# DEVELOPMENT REVIEW COMMITTEE (DRC) COMMENT REPORT

**PROJECT NAME:** The Mile Hotel, East

**CASE NUMBER:** UDP-S23021

**REQUEST:** Site Plan Level III Review: Use Greater than 10,000 Square-Foot in Community Business District for 70-Room Hotel with 9,000 Square foot Retail Use with Associated Parking Reduction Request

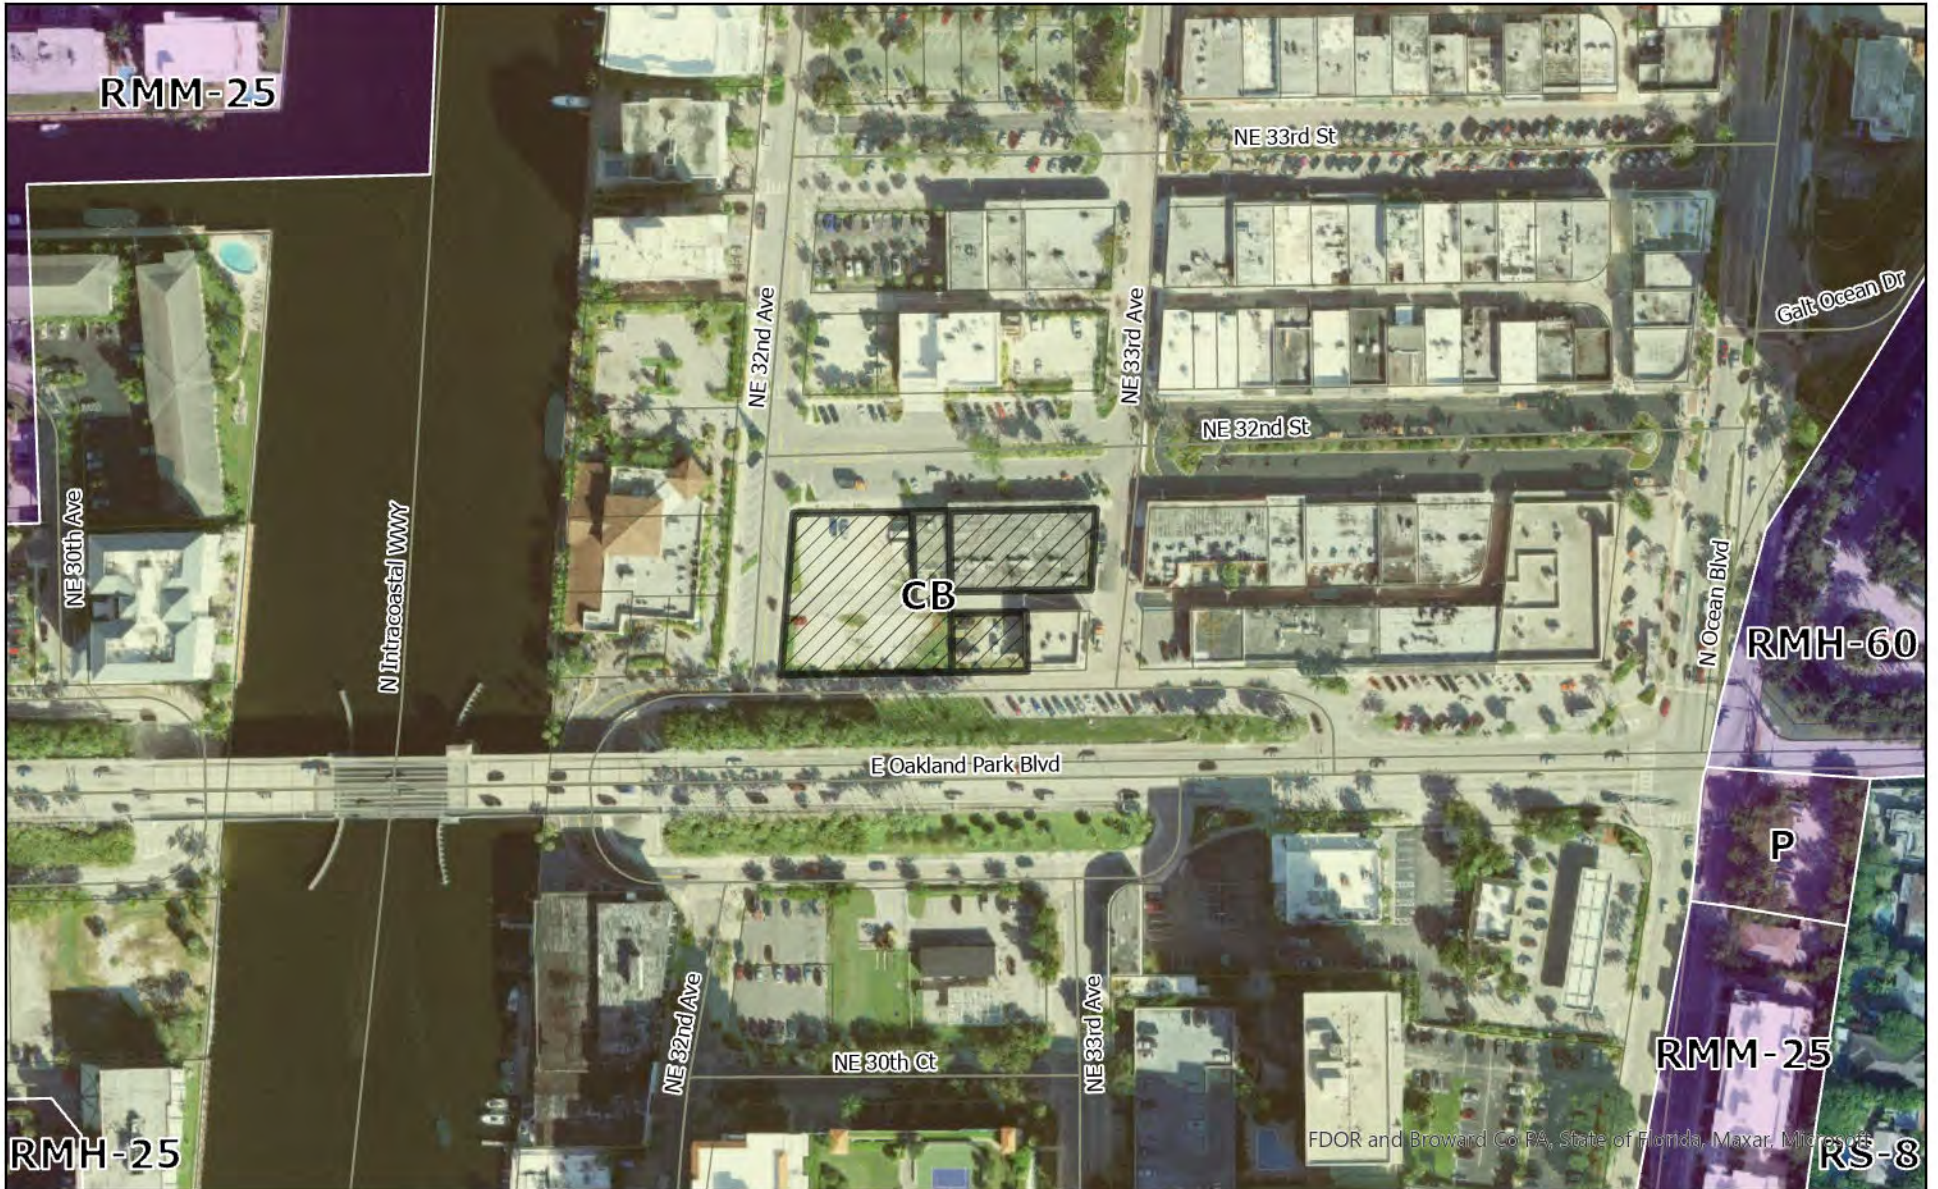
22. On the north portion of the property, it appears that improvements are being proposed outside of the property boundaries, such as sidewalk, landscaping, and parking. Provide clarification and intent of the

proposed improvements. Since the improvements are being proposed outside the property's boundaries, provide additional information regarding how maintenance will be performed.
